Request	-	Special Use Permit for a Washington Local Schools operations building
Location	-	2162 W. Alexis Road
Applicant/ Owner	-	Washington Local Schools 3505 W. Lincolnshire Blvd. Toledo, OH 43606
Architect	-	The Collaborative One SeaGate, Park Level 118 Toledo, OH 43604

The staff recommends that the Toledo City Plan Commission recommend **approval** of SUP25-0033, a Special Use Permit for Washington Local Schools operations building at 2162 W. Alexis Road, to Toledo City Council for the following **two (2) reasons**:

SPECIAL USE PERMIT
TOLEDO CITY PLAN COMMISSION
REF: SUP25-0033
DATE: October 9, 2025
TIME: 2:00 P.M.

SHEET TITLE
**PROPOSED SITE
PLAN**

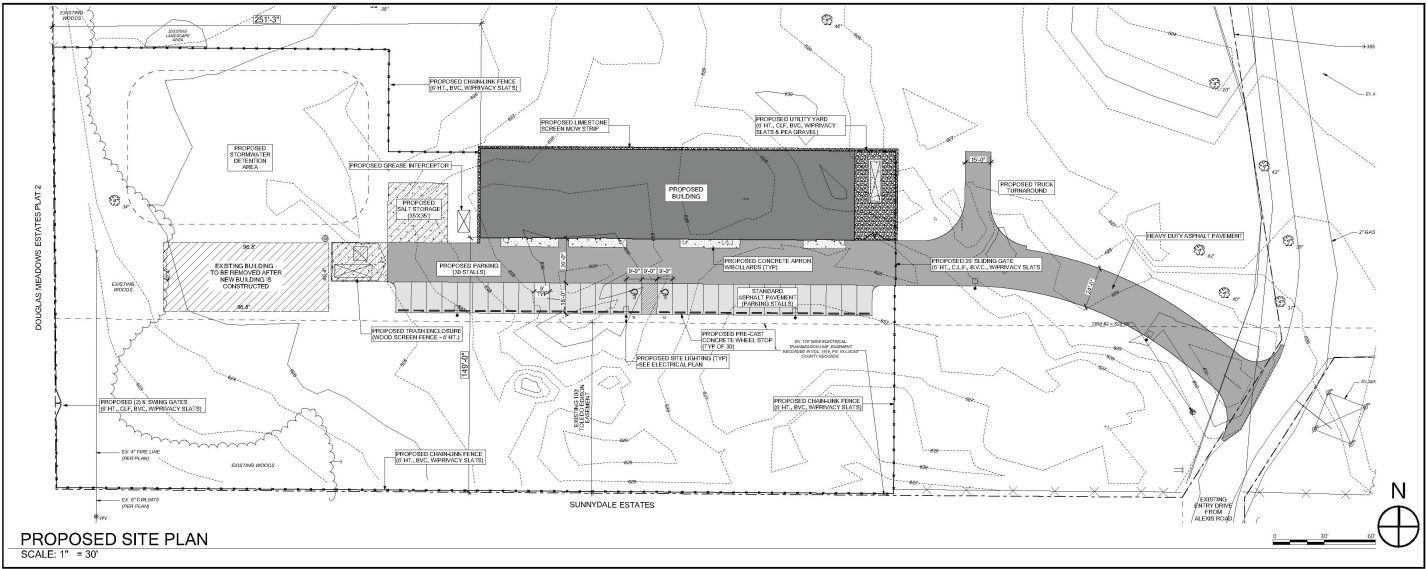
An asphalt drive and parking area will be constructed from the existing drive to Alexis Road for access to the proposed operations building. WLS has an access easement agreement to utilize the existing drive to Alexis Road. Based on the uses proposed for the building, a maximum of thirty-one (31) parking spaces are permitted. Thirty (30) parking spaces with wheel stops are proposed; therefore, the proposal meets the maximum off-street parking space requirements of Schedule A in TMC§1107.0304, and the requirement for wheel stops in TMC§1107.1907. Based on the thirty (30) proposed parking spaces, three (3) bicycle parking slots are required. No bicycle parking slots are provided; therefore, the site plan shall be revised to show the required bicycle parking slots and listed as a condition of approval.

Accessible off-street parking is required per TMC§1107.1700 at a rate of one (1) car-accessible and one (1) van accessible parking space, when there are twenty-five (25) to fifty (50) total parking spaces. The proposed site plan meets this requirement as two (2) van accessible parking spaces are provided. As noted by the Division of Transportation in Condition #34, per TMC§1107.1703 and the Americans with Disabilities Act, accessible parking spaces shall be the closest parking spaces to the building entrance. As such, the proposed accessible parking spaces shall be moved to the east to be in line with the main entrance of the building and listed as a condition of approval.

2. A proposal which infiltrates stormwater runoff such as this site plan suggests, rather than discharging off site, would be acceptable conditioned on providing calculations which show infiltration is feasible without inadvertently running discharge across property lines, and if a storage basin is utilized as shown, that it empties at an adequate rate to make available more storage volume for the next storm.

33. Bicycle parking is required per TMC§1107.0900.
34. Accessible parking must be the closest parking space to the accessible entrance for the shortest path of travel per Americans with Disabilities Act and TMC§1107.1703.
35. Stripe a cross-walk from accessible parking loading aisle to the front entrance.
36. Accessible parking signage must be posted directly in front of the parking space at a height of no less than sixty inches (60") and no more than seventy-two inches (72") above pavement level per TMC§1107.1704.
37. All driveways, drive approaches and drive aisles must be a minimum of twenty-five feet (25') wide where two-way traffic is being utilized per TMC§1107.1911.

38. Further development of the site by WLS will require rezoning the property to IC Institutional Campus and submitting an IC master plan.
39. Three (3) bicycle parking slots are required based on the thirty (30) proposed parking spaces per Schedule A in TMC§1107.0304. **No bicycle parking slots are provided. Not acceptable as depicted. The required bicycle parking slots shall be provided and a revised site plan submitted.**

40. Two (2) accessible parking spaces are required per TMC§1107.1700. These spaces shall be the closest parking spaces to the accessible building entrance. Two (2) van accessible parking spaces are provided; however, they are not the closest spaces to the main entrance. **Not acceptable as submitted. The proposed accessible parking spaces shall be moved to the east to be in line with the main entrance of the building.**

SHEET TITLE
**SITE
LANDSCAPE
PLAN**

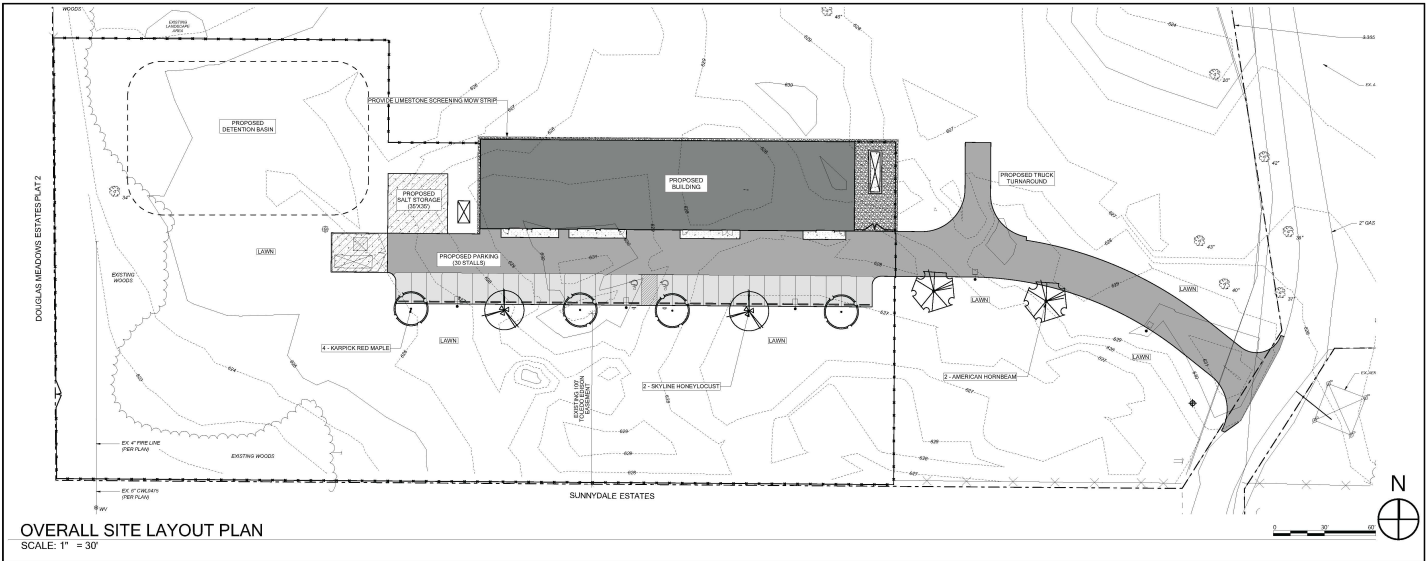
The submitted landscape plan shows that the existing wooded area along the west property line and a portion of the south property line will be retained in the area of the proposed development. In addition, a six-foot (6') high chain-link fence with privacy slats is illustrated on the site plan surrounding the proposed development. As noted previously, future development of the remaining site will require rezoning and submission of an IC master plan. This will require a Type "A" buffer along the property line of the subject property and abutting RS6 and RM36 zoning districts per TMC§1108.0203. A Type "A" buffer shall therefore be provided along the south and west portions of the submitted proposal as a condition of approval. This buffer shall be a minimum of twenty-five feet (25') in width with four (4) canopy trees per 100 linear feet. The existing woods as illustrated on the plan meets this requirement; however, five (5) canopy trees shall be provided for the portion of the southern property line for which there is no existing woods. Shrubs are also required unless a fence, wall, or berm six feet (6') to eight feet (8') in height is provided. While a chain-link fence with privacy slats is proposed, chain-link fencing is not permitted to be used to meet buffers and screening requirements per TMC§1108.0404(B). Therefore, a privacy fence shall be installed instead of the proposed chain-link fence with slats. The fence and canopy trees required along the southern property boundary shall extend to the existing access drive. The landscape buffer requirements are listed as a condition of approval.

Interior parking lot landscaping is also required at a rate of two (2) canopy trees and six (6) shrubs for each ten (10) parking spaces per TMC§1108.0204(C). Therefore, six (6) canopy trees and eighteen (18) shrubs are required. Eight (8) trees are illustrated on the landscape plan. The required eighteen (18) shrubs shall be provided and listed as a condition of approval.

- a. A Type “A” landscape buffer shall be provided along the south and west portions of the submitted proposal where the abutting property is residentially zoned. This buffer shall be a minimum of twenty-five feet (25’) in width with four (4) canopy trees per 100 linear feet. The existing woods, as illustrated on the landscape plan, meet this requirement; however, five (5) canopy trees shall be provided for the portion of the southern property line for which there is no existing woods. In lieu of the required shrubs, a privacy fence shall be installed. The proposed chain-link fence with slats does not meet this requirement. The fence and canopy trees required along the southern property boundary shall extend to the existing access drive. **Not acceptable as depicted. The required buffer shall be provided and depicted on a revised landscape plan.**

- b. Interior parking lot landscaping is required at a rate of two (2) canopy trees and six (6) shrubs for each ten (10) parking spaces per TMC§1108.0204(C). Six (6) canopy trees and eighteen (18) shrubs are required. Eight (8) trees are illustrated on the landscape plan. **Not acceptable as depicted. The required eighteen (18) shrubs shall be provided and depicted on a revised landscape plan.**

- f. The location, number, height, diameter and species of any materials to be planted and maintained, as well as the location and number of any existing trees to be preserved. **The plant schedule shall be updated to reflect the additional required landscape.**

- h. The location, height and materials for any fencing to be installed and maintained. **Not acceptable as depicted. A privacy fence shall be provided instead of the proposed chain-link fence with slats.**

ELEVATIONS

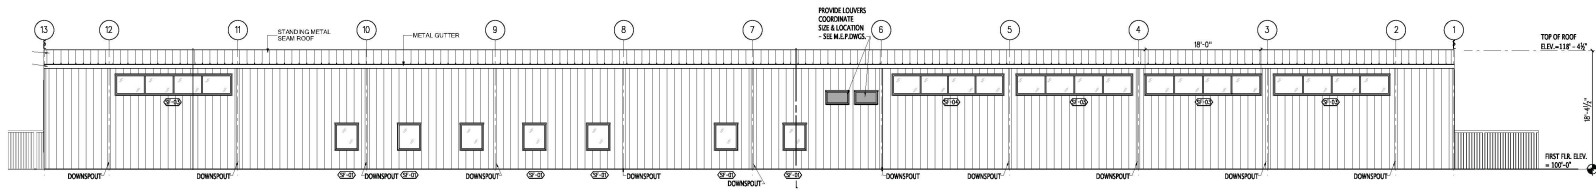
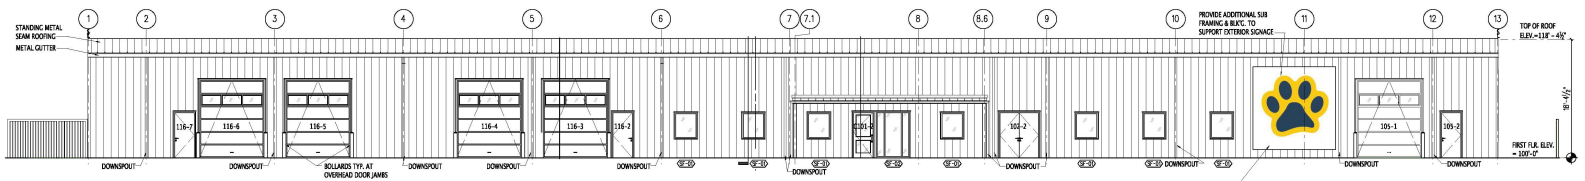
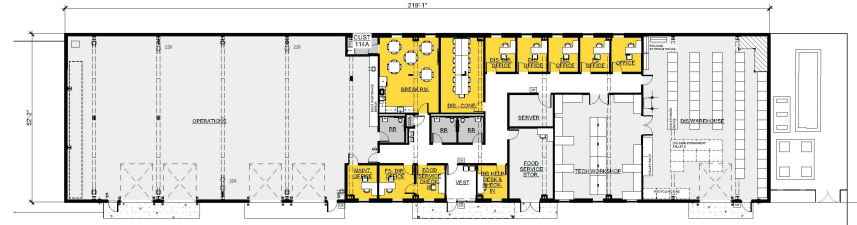
Two building signs are illustrated on the submitted building elevations. One is a panther paw and the other is a sign with words that look to be part of the WLS Mission and Vision Statements. Per TMC§1113.0303, building signs are limited in size based on building wall frontage that faces a public street. The building is not on a public street; therefore, signage is not permitted. Due to the nature and use of the site, staff acknowledges the need for identification signage for those visiting the operations building. Staff therefore recommends that signage be permitted as part of the Special Use Permit in the form of a directional sign where the proposed drive to the operations building intersects with the existing access drive, and a building sign that identifies the building by name and /or address. Neither of these signs shall be lighted, and sign permits shall be submitted for all signage. These are listed as conditions of approval.

42. Salt storage building elevations/details shall be submitted to determine compliance with the design standards in Chapter 1109.
43. Building signage is not permitted per TMC§1113.0303. Due to the nature and use of the site, signage shall be permitted as part of the Special Use Permit in the form of a directional sign where the proposed drive to the operations building intersects with the existing access drive, and a building sign that identifies the building by name and /or address. Neither of these signs shall be lighted, and sign permits shall be submitted for all signage.
